**TO:** Chairwoman Nicole Love Hendrickson, Gwinnett County Commission  
**ATTN TO:** Sushmita Arjyal, Current Planning Supervisor, Gwinnett County  
**FROM:** Mike Alexander, Director, ARC Center for Livable Communities  
**RE:** Development of Regional Impact (DRI) Review

**Name of Proposal:** Brand Properties Hamilton Mill DRI 3812

**Description:** A DRI review of a proposal to construct a mixed-use development with 700 multifamily units and 17,000 square feet of commercial space on a 79-acre site off Sardis Church Road in unincorporated Gwinnett County.

## DRI SITE PLAN

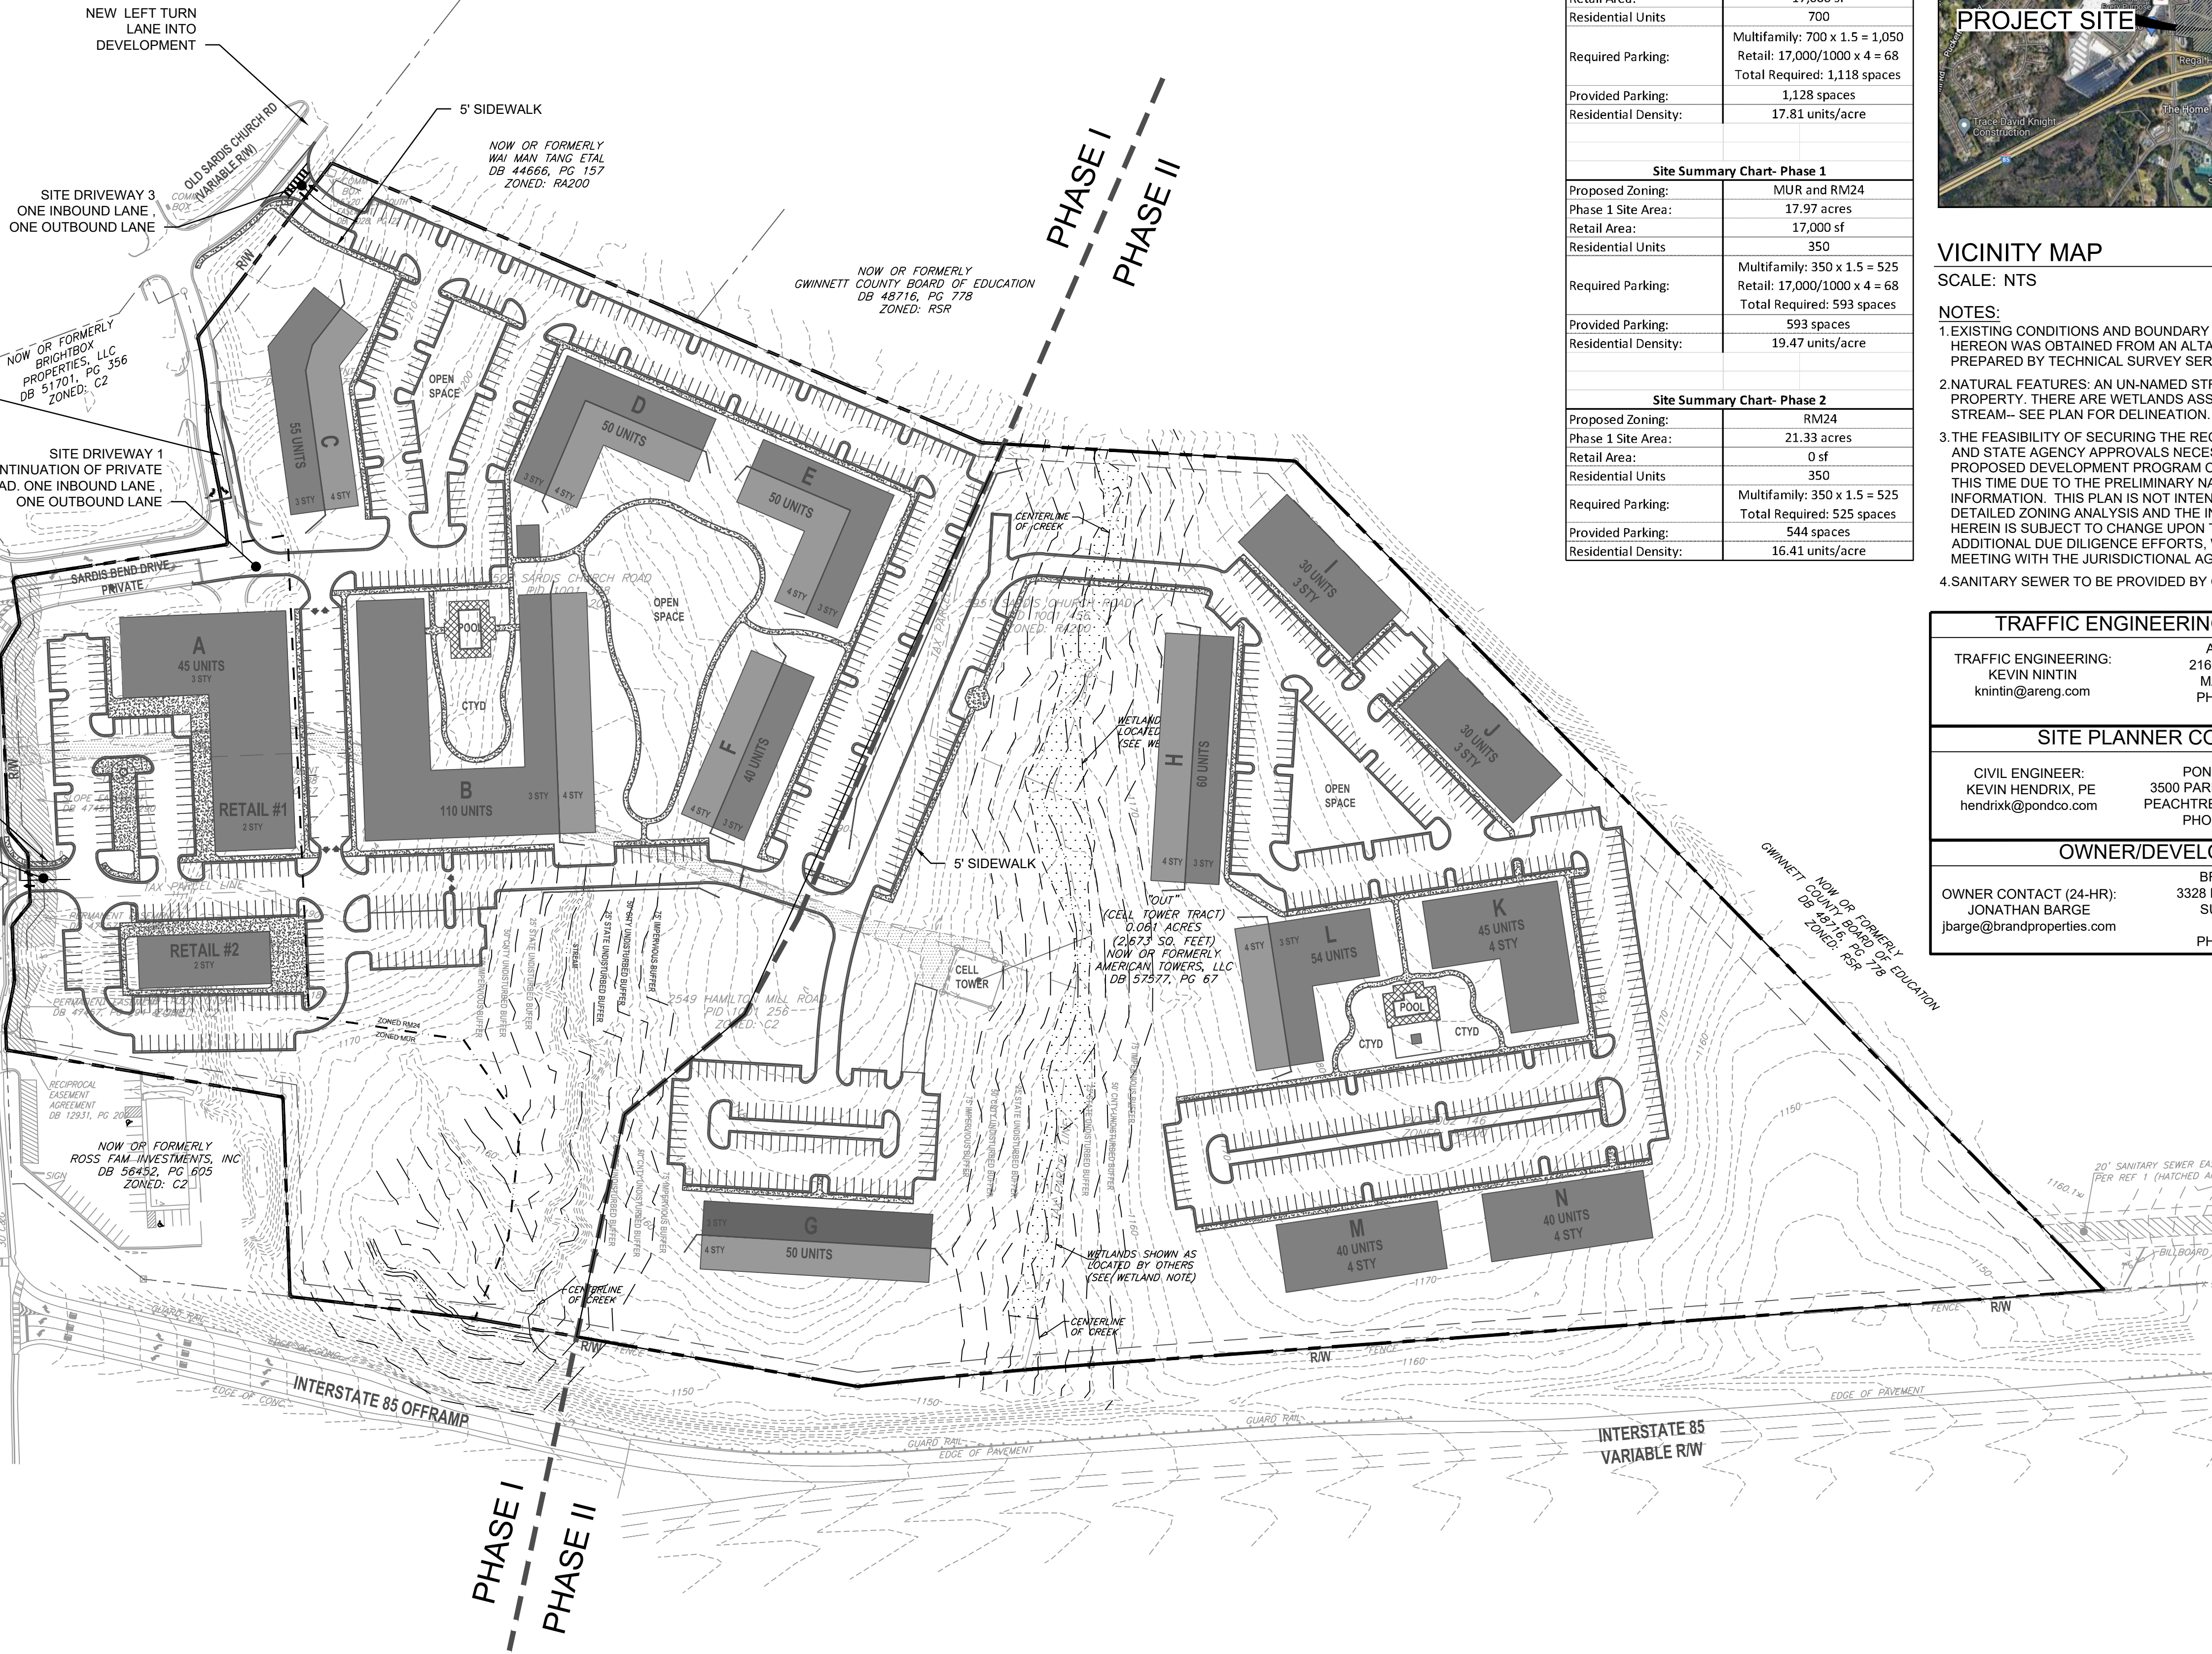
*A total of 2,250 parking spaces are provided which is marginally more than the number required. Regional multi-modal transportation policies are supportive of reduced parking and a modest parking reduction may be warranted.*

*No EV charging spaces appear to be identified; provision of adequate EV charging spaces would be supportive of regional EV infrastructure policies.*

*Several buildings and parking areas appear to abut or intrude somewhat into mapped stream buffers. The buffers seem to be truncated adjacent to buildings B and F. Any intrusions into the stream buffers will require variances to the County Stream Buffer Ordinance and the State 25-foot Sediment and Erosion Control buffer as applicable.*

Both the USGS coverage for the project area and the project site plan show an intermittent blue-line stream at the southern boundary of the property next to the I-85 off ramp to Hamilton Mill Road. This submitted site plan also shows two streams running north south through the project property, one flowing into the mapped intermittent blue-line by I-85. The 50-foot undisturbed buffer and 75-foot impervious setback required under the County Stream Buffer Protection Ordinance as well as State 25-foot Sediment and Erosion Control buffer are shown on the plans. A driveway crossing is shown in Phase II, but crossings are generally exempt under the County buffer ordinance. However, Building H on the plans nearly abuts the 75-foot buffer on one stream, as does a parking area on the opposite side of that creek, and two parking areas nearly touch the 75-foot buffer on the tributary to the mapped blue-line creek. All are in Phase II of the project. Also, in Phase I, the creek and its buffers stop at the parking area and driveway for Buildings B and F. In all these cases, any intrusions into the stream buffers will require variances to the County Stream Buffer Ordinance and the State 25-foot Sediment and Erosion Control buffer as applicable.
